Community Center Complex

Addendums

ADDENDUM #1

SACRAMENTO COMMUNITY CENTER COMPLEX

VERTICAL SHAFT COVER

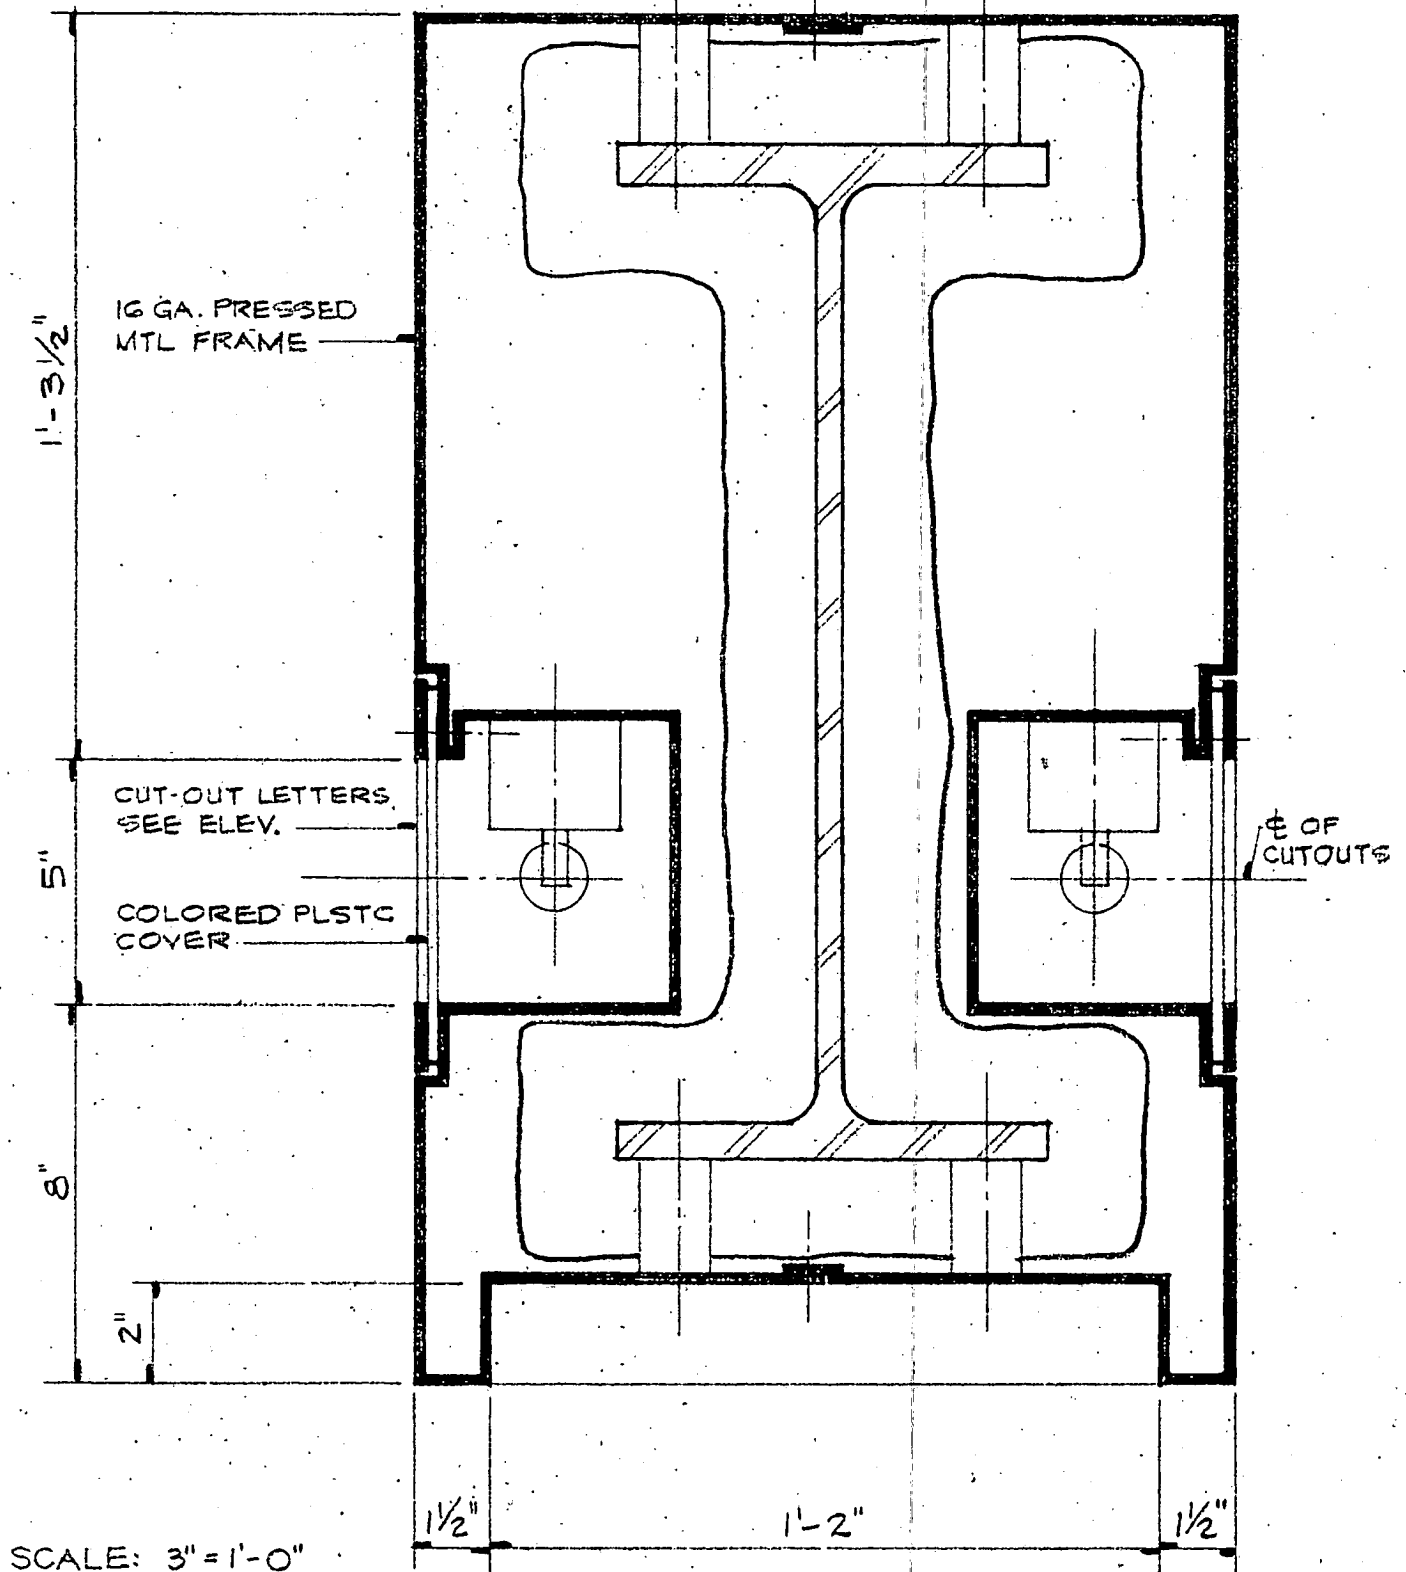
"Modify Section B of Sheet A3-7, vertical shafts 04 and 09,
to conform to Addenda Drawing No. 2"

Change wall material at shafts 04 and 09 from Hard Coat Plaster as shown to cement plaster system shown in Addenda drawing.

ITEM # 56

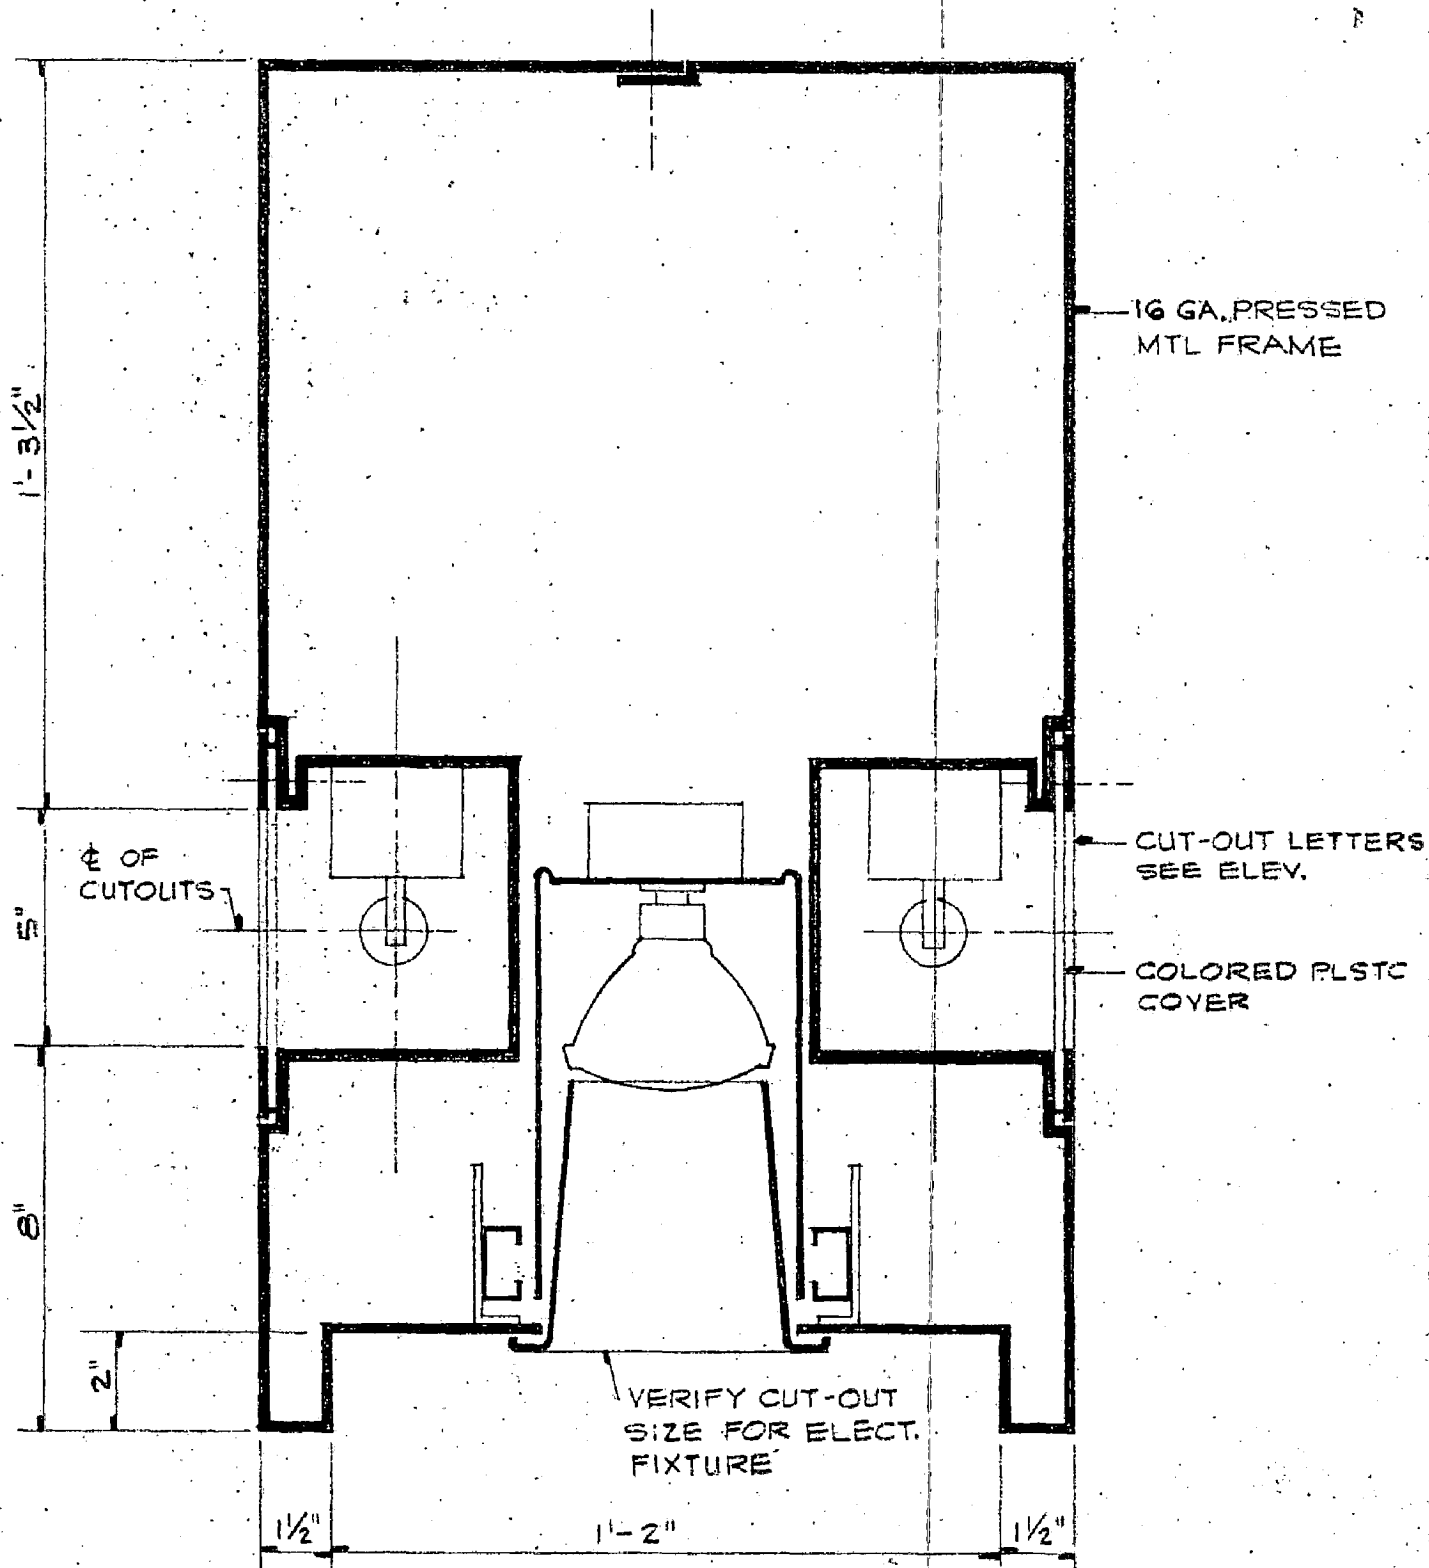
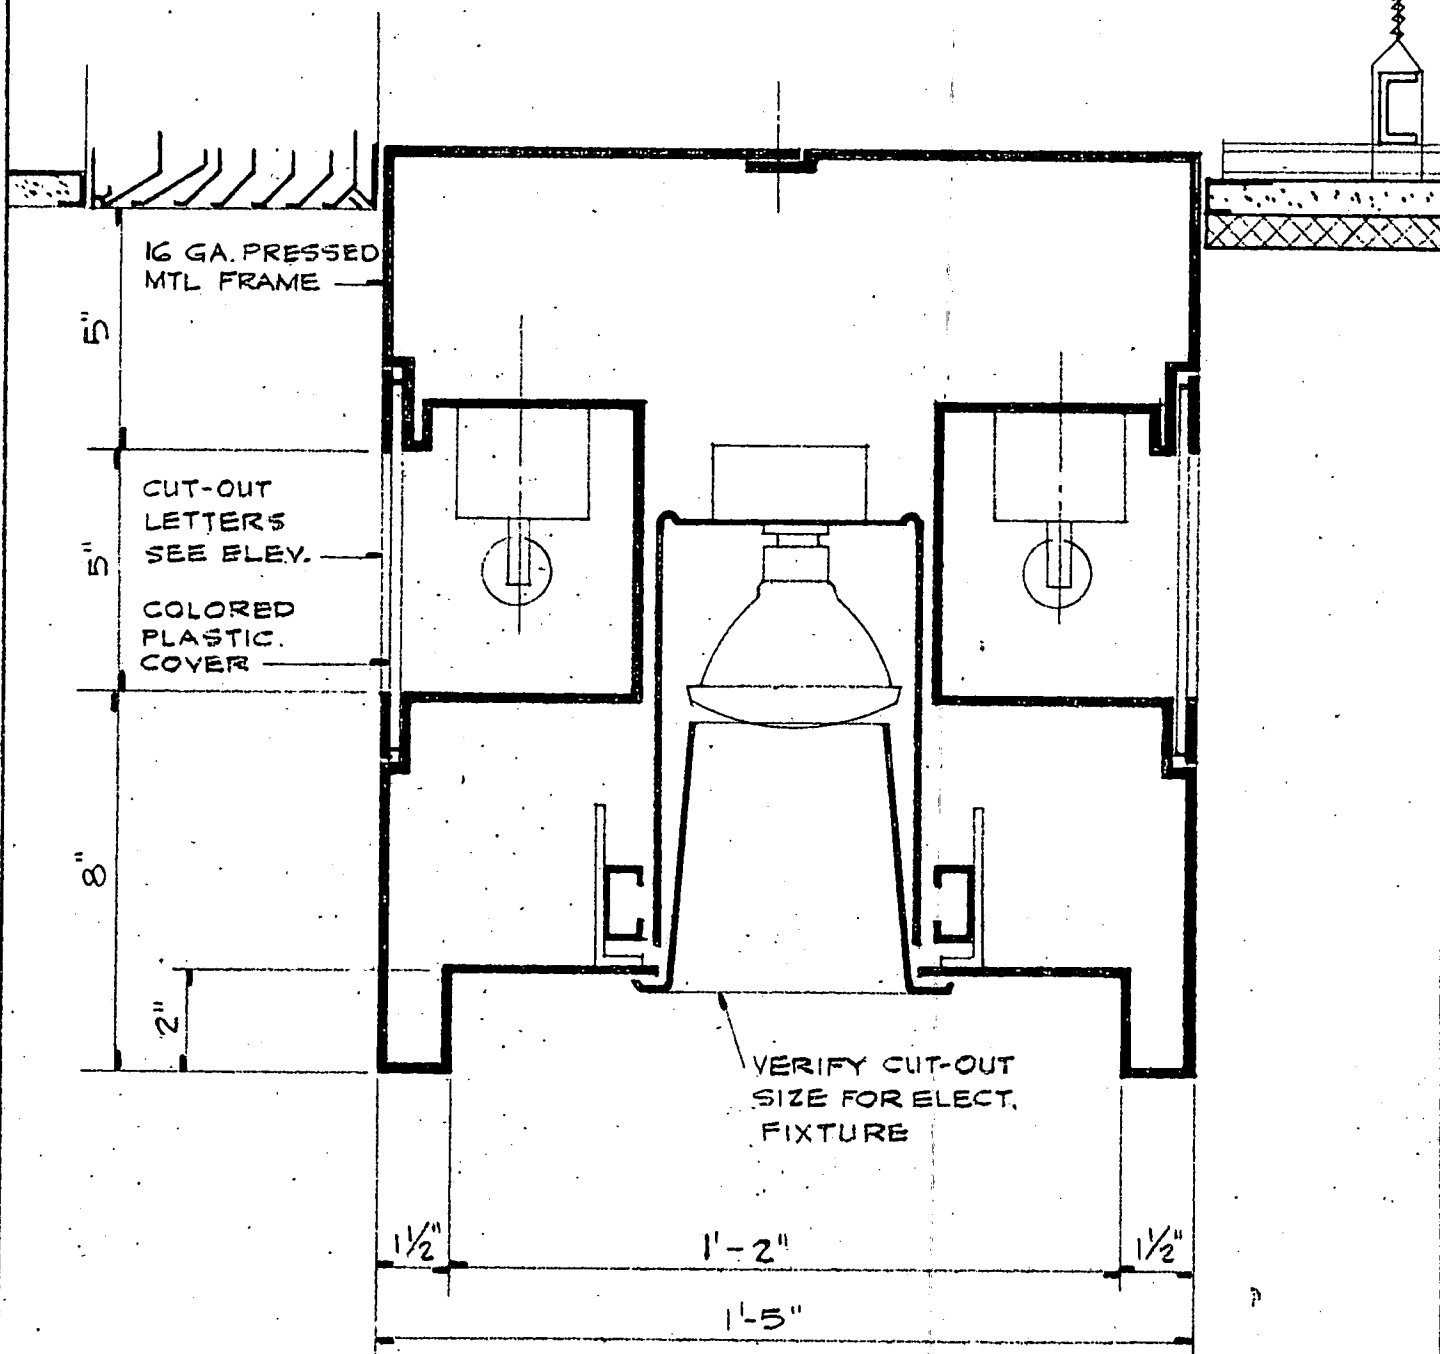
Addenda Drawings No. 3,4 and 5 delineate the pressed metal beam light fixtures at the Theater Promenades. If additional joints are required in fixtures, submit shop drawings to clarify desired locations.

NOTES: SUBMIT SHOP DRAWINGS TO CLARIFY LOCATIONS AND NUMBERS OF BREAKS.

ADDENDUM NO 2
ITEM # 177

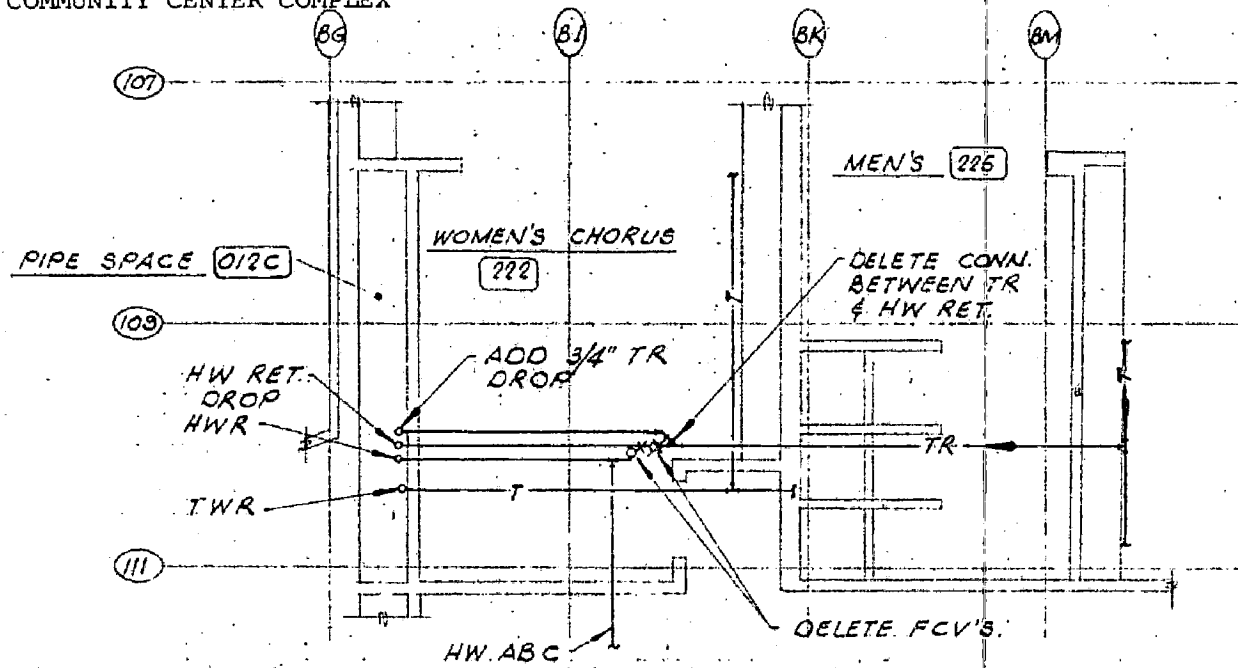
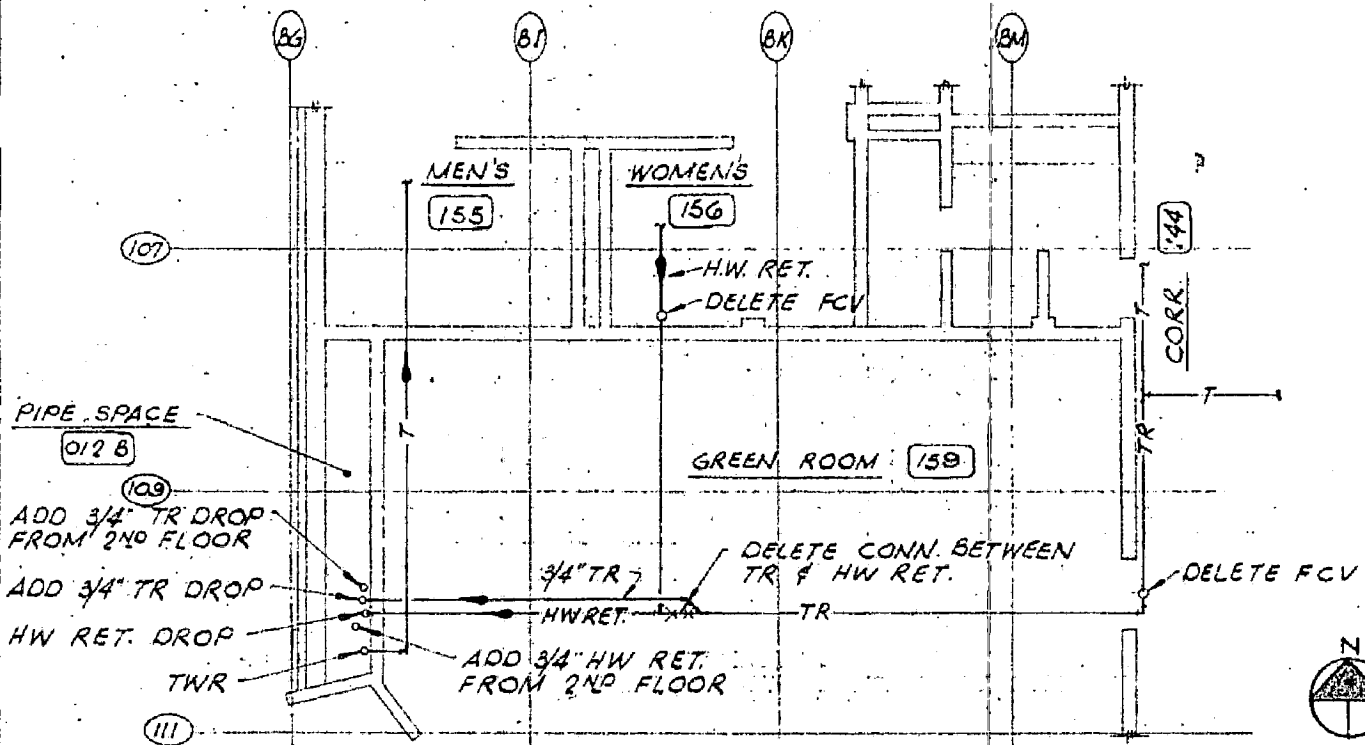
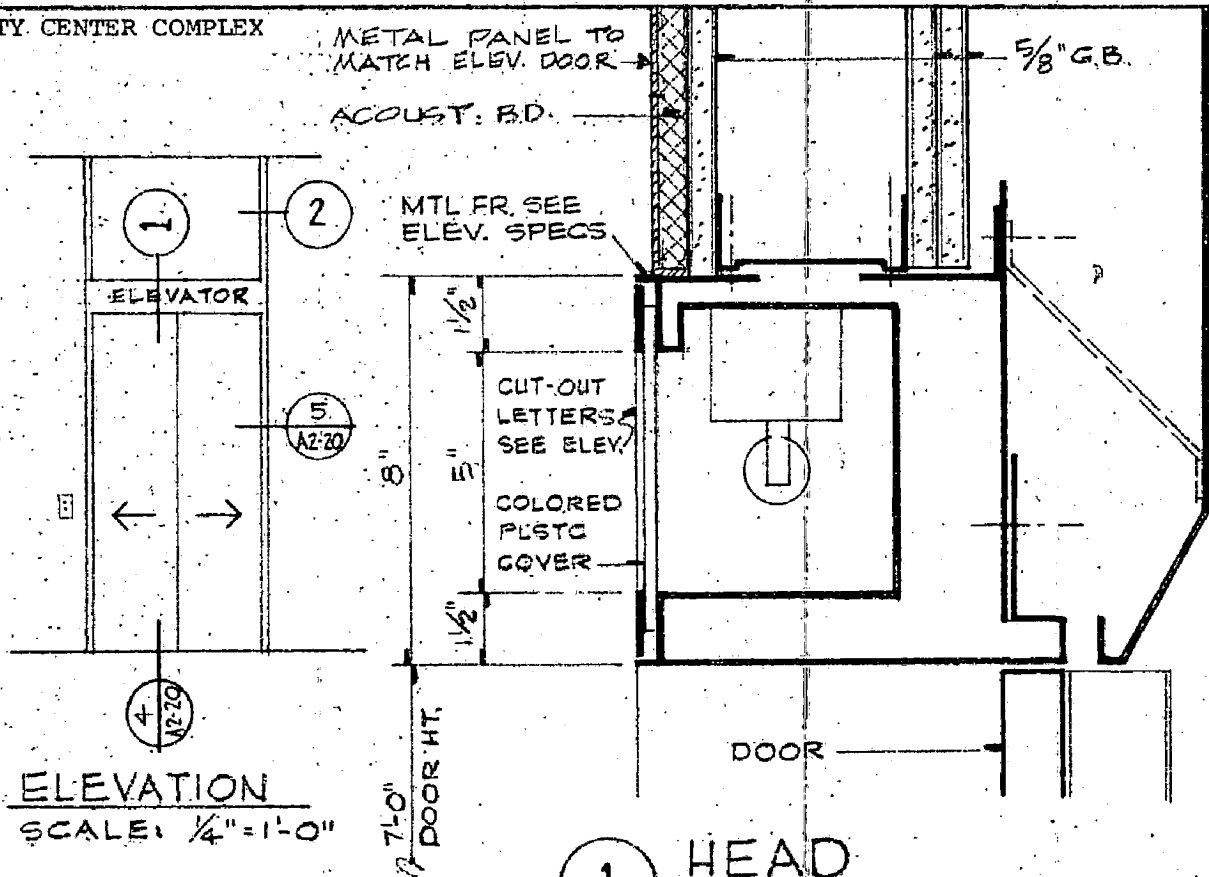
Addenda Drawings #6, 7, 8, 9, 10 and 11 - Show revisions to the tempered water system.
